45 The Vineyard Planning Changes

Date: August 2024
Doc No. 5008

Revision G

Since activating the planning permission (ref 19/0954/VRC) the scheme has undergone both a stage 3 design review and stage 4 design development. This document seeks to present the design updates with a view to substituting the existing planning drawings with an updated set to maintain the completeness of the consent, for the avoidance of doubt and in the interests of proper planning. The design updates have been made for the following reasons:

Drawing Title:
**SECTION DD
PROPOSED**

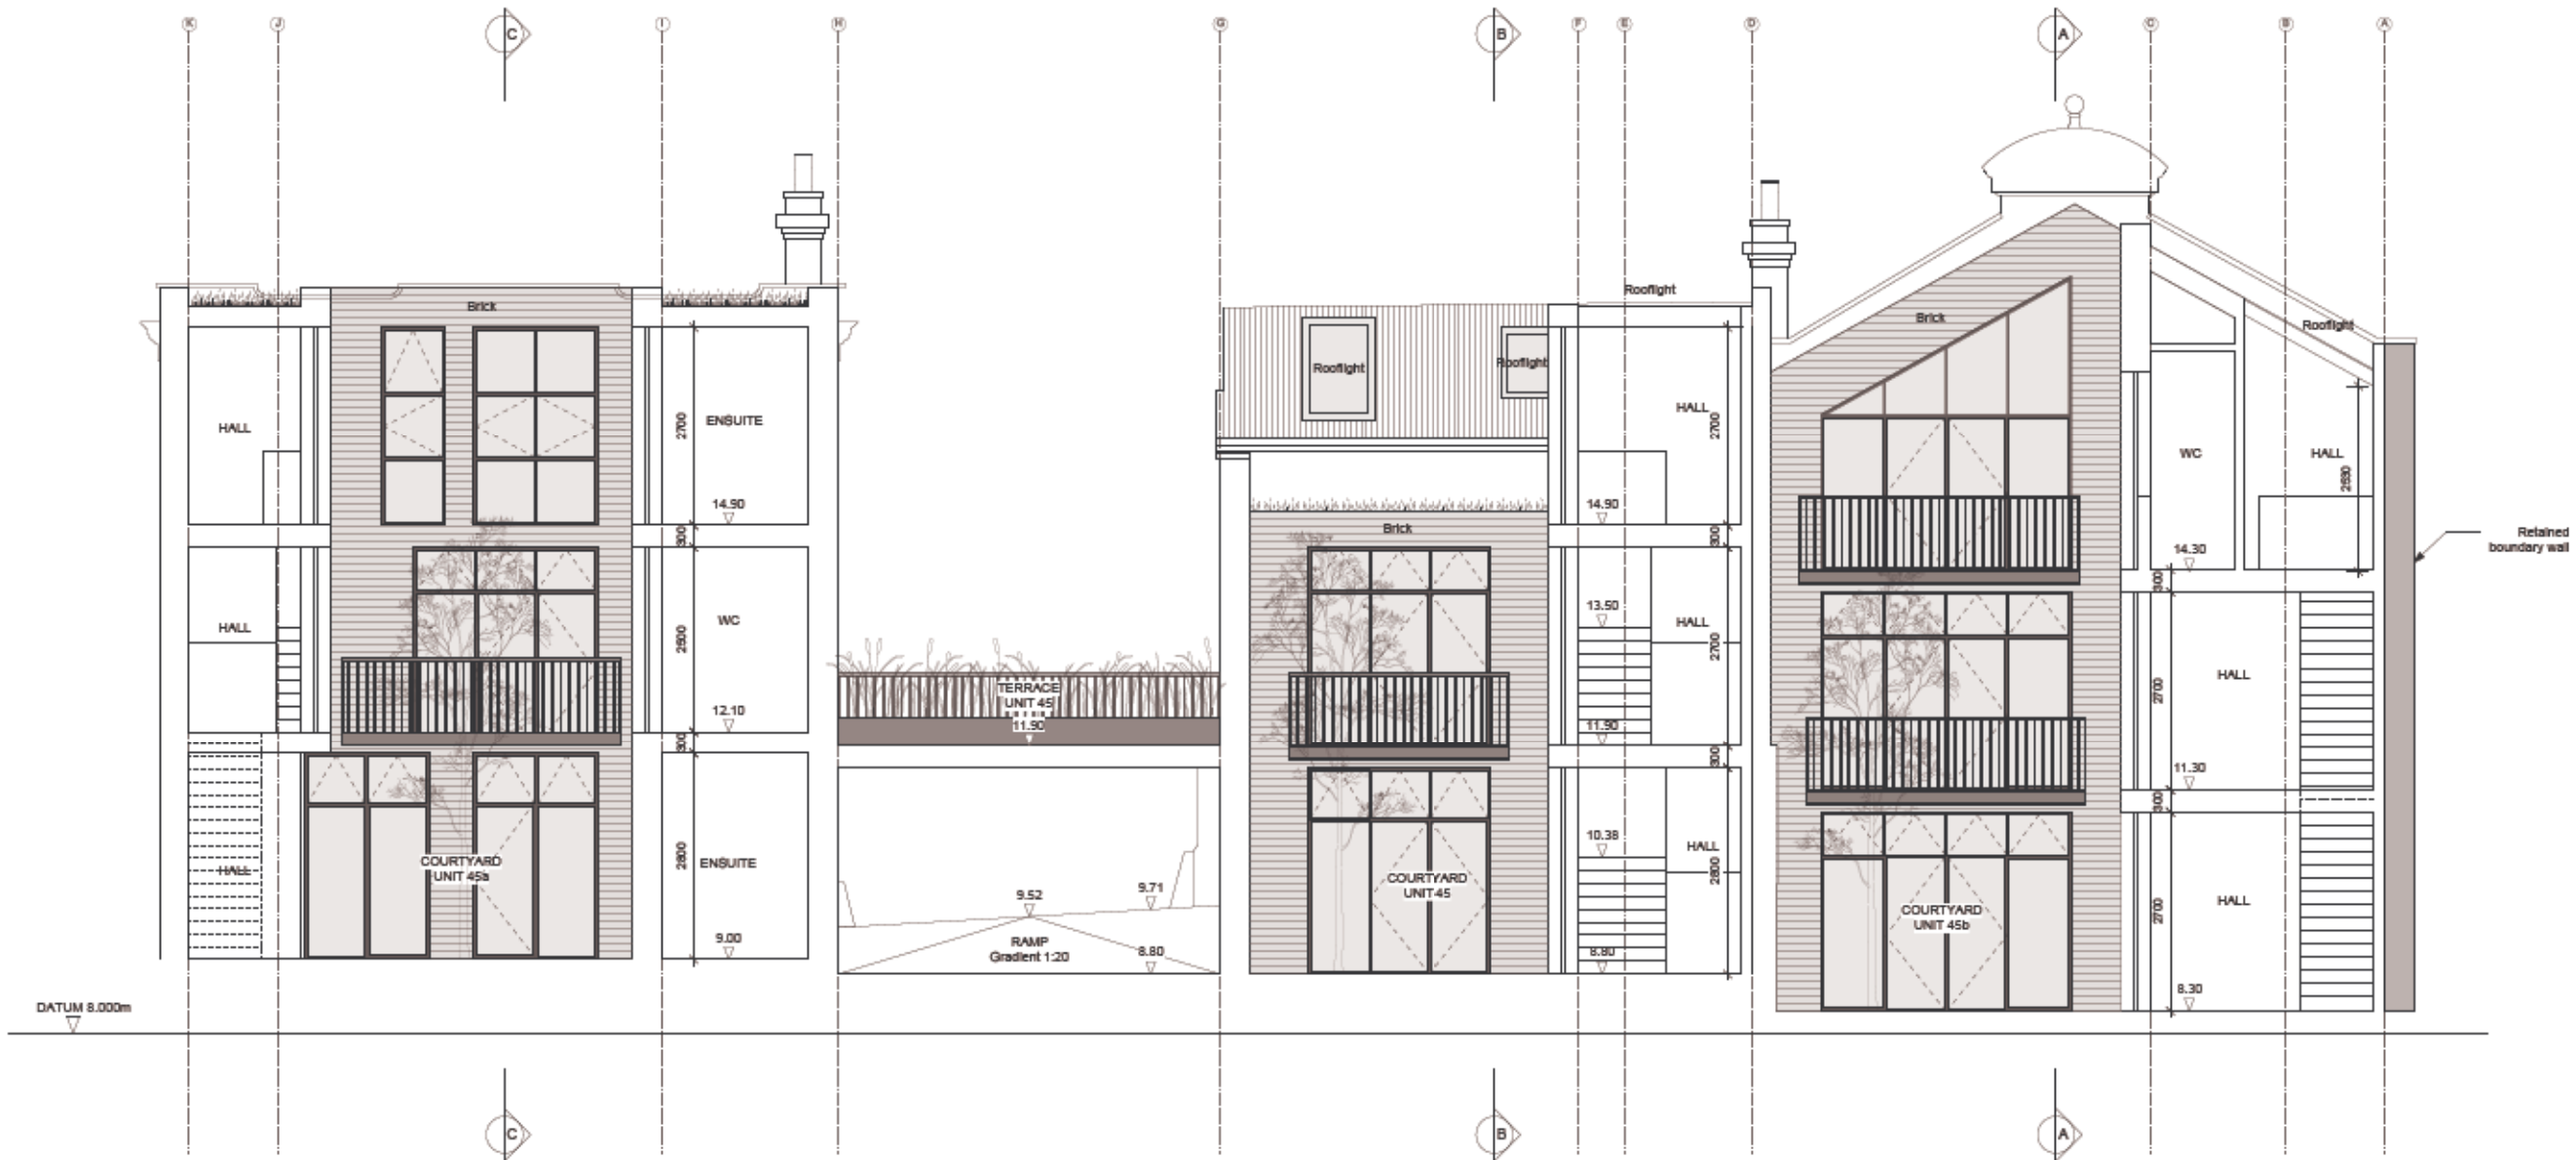
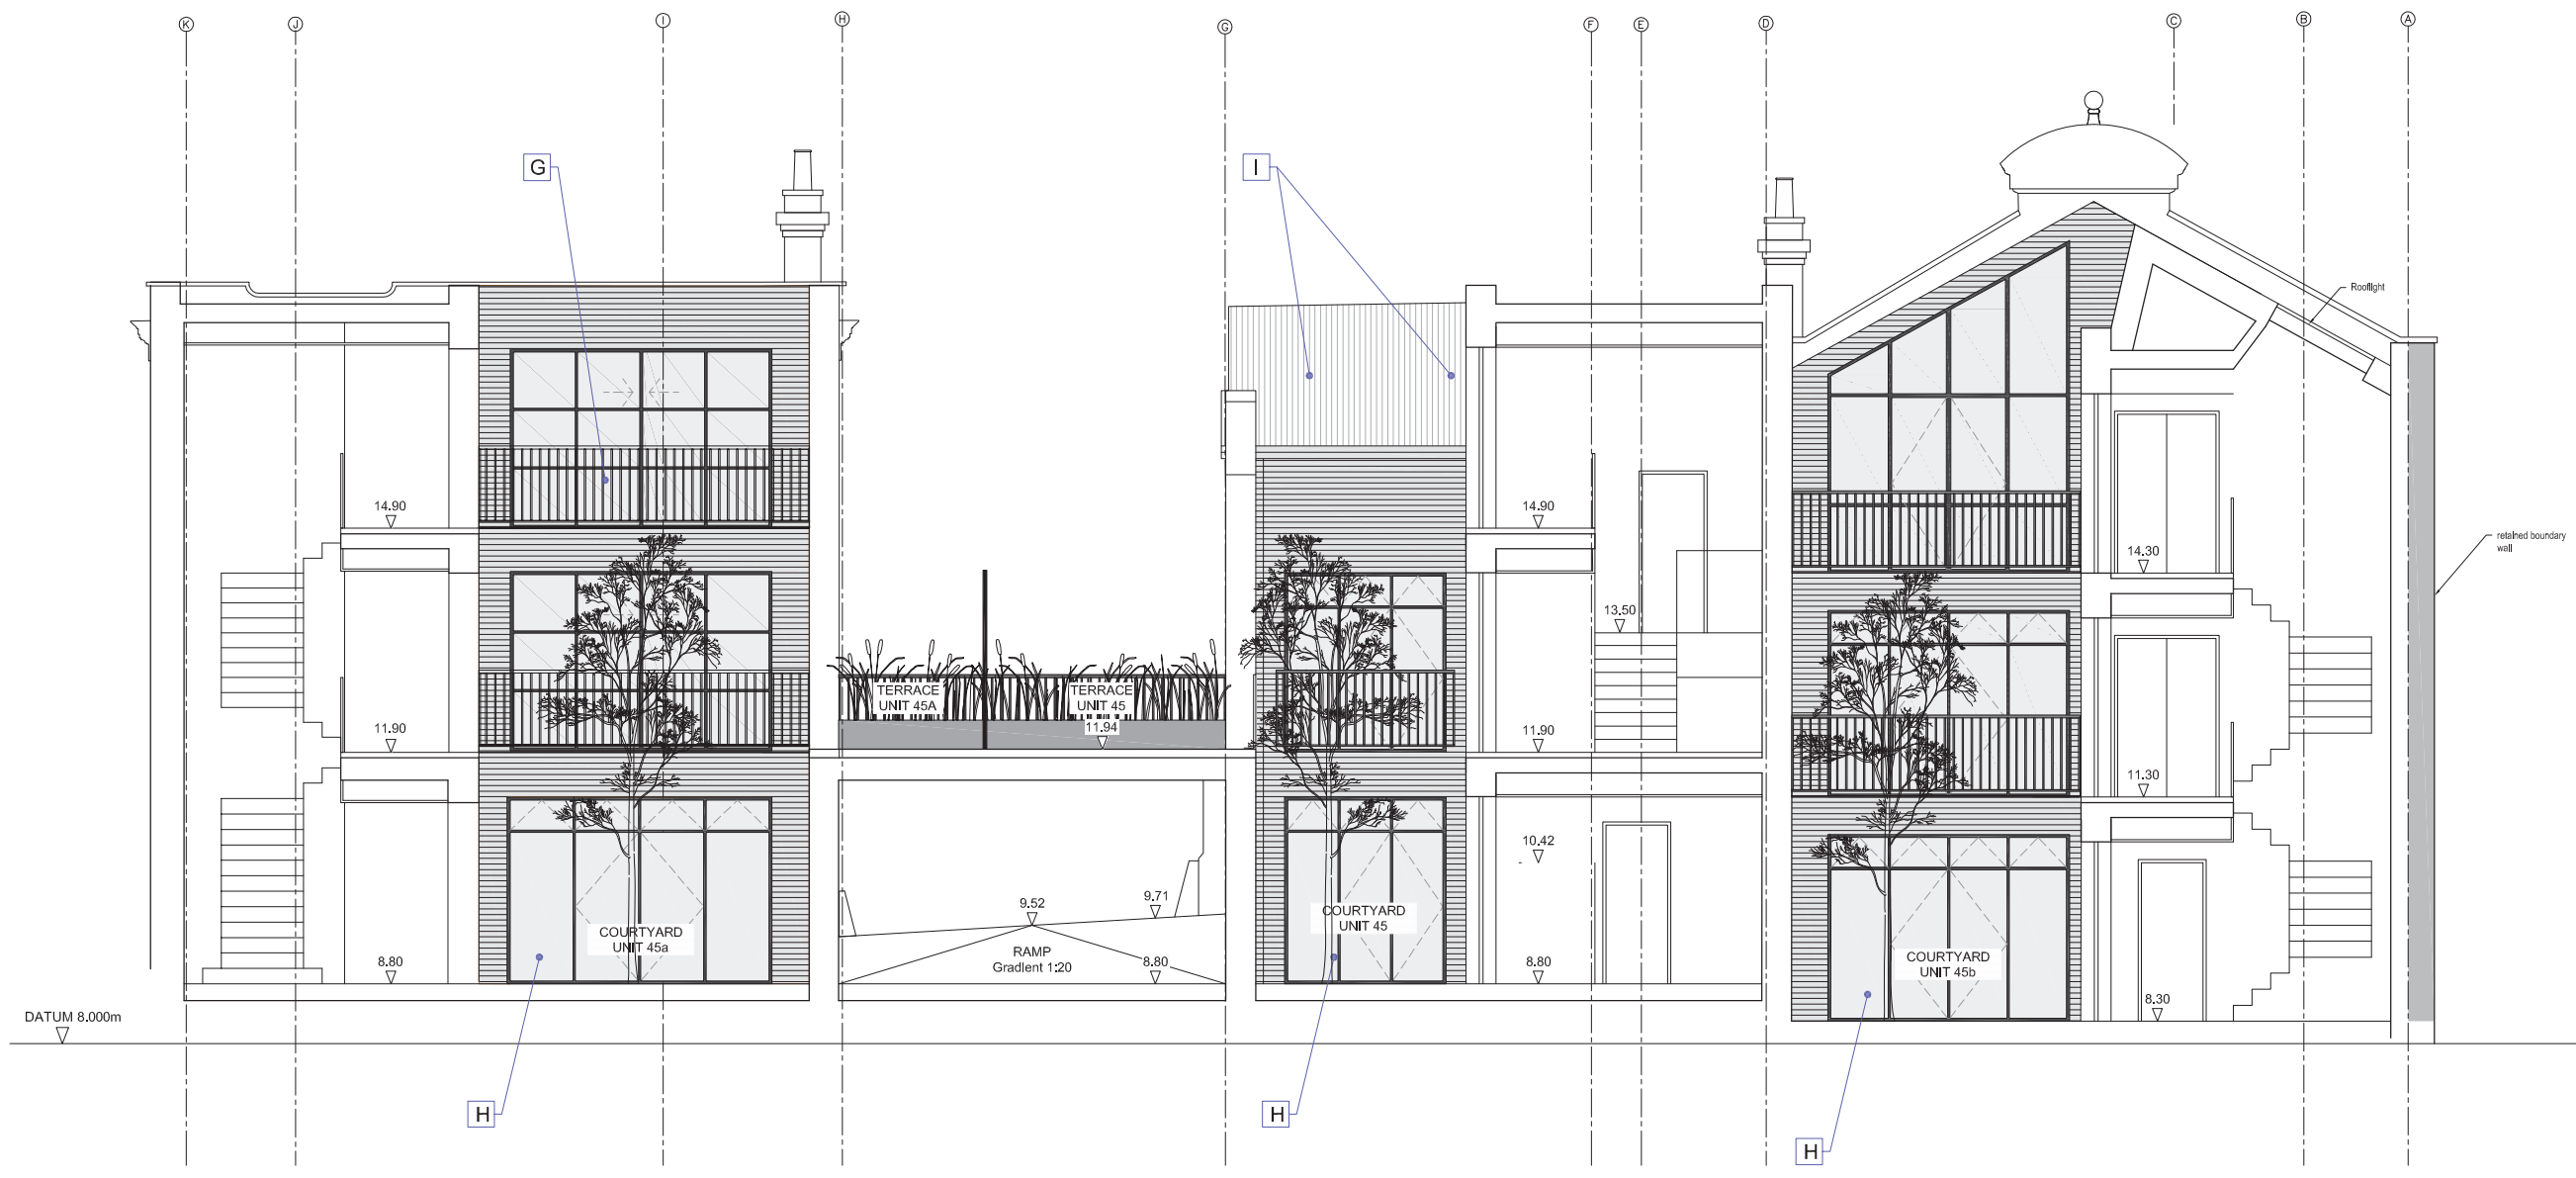
- A INTERNAL ARRANGEMENT AMENDED (SEE SUMMARY OF INTERNAL CHANGES IN SEPARATE DOC)
- B BICYCLE STORAGE ARRANGED AROUND COURTYARD (CLOSER TO UNIT ENTRANCES)
- C LEVEL ENTRANCE TO 45A
- D ENTRANCE LEVEL SHOWN HERE (BEDROOM SHOWN ON LEVEL 02) - NOTE: ACTUAL LEVEL TO THESE ROOMS REMAINS THE SAME
- E TERRACE DIVIDED BETWEEN UNITS WITH GREEN WALL
- F COURTYARD FLANK WALL LOWERED IN HEIGHT (SEE ELEVATION)
- G TERRACE ADDED
- H WINDOW AMENDED (POSITION OR SIZE)
- I ROOFLIGHT OMITTED
- J GREEN ROOF OMITTED
- K -
- L SOFFIT PROFILE CHANGED
- M BRICK SOLDIER COURSE OMITTED
- N SERVICE ENCLOSURES CHANGED
- O PRIVACY SCREEN ADDED
- P CAR PARK GATE AMENDED
- Q PLANT ROOM DOOR ADDED
- R WINDOW POSITION AMENDED
- S -
- T PV PANEL ADDED
- U WINDOW OMITTED
